Intel[®] 6300ESB I/O Controller Hub (ICH)

Specification Update

July 2008

Order Number: 300884-013

Figure 1. Board Workaround for PCI-X Secondary Bus Reset Functionality

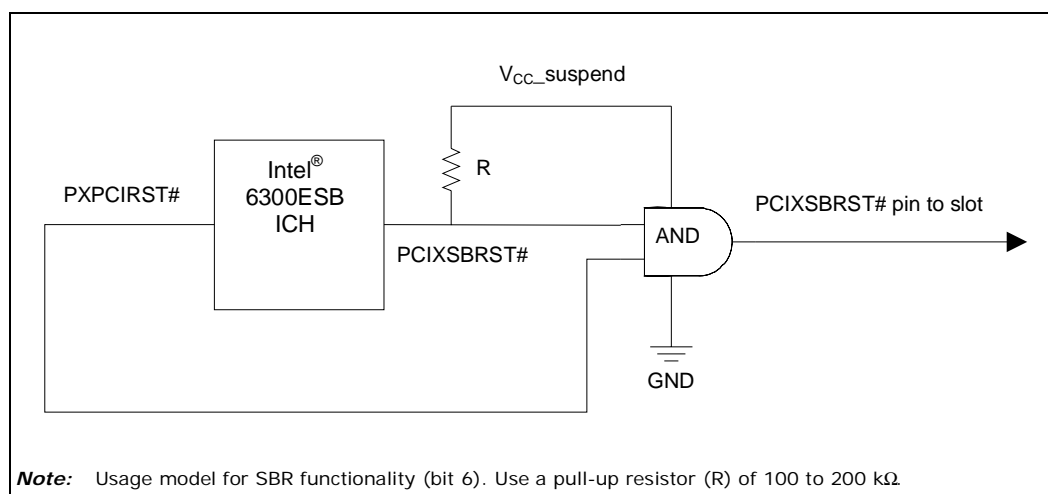
Problem: The Secondary Bus Reset pin (PCIXSBRST#) on the PCI-X bus is internally tied to the Vcc_core well. When the system goes into S3 state (sleep), this signal is floating due to Vcc_core going away.

Implication: System will not WOL when PCIXSBRST# is connected directly to the PCI-X slots.

Workaround: A board workaround pulls the PCIXSBRST# pin up to Vcc_suspend through a resistor (R). This pin is also ANDed with the PXPCIRST# pin so that if the PCI-X bus resets, the signal that is routed to the slot reflects the reset. Also, since the AND signal is powered by Vcc_suspend, when the system goes into sleep state (S3), this voltage is still present and the correct voltage is applied to the signal that is routed to the slot. See Figure 1 below.

Status: No fix. This board workaround is to be used if customers plan to utilize this SBR feature. If not, the PCIXSBRST# pin is to be not connected.
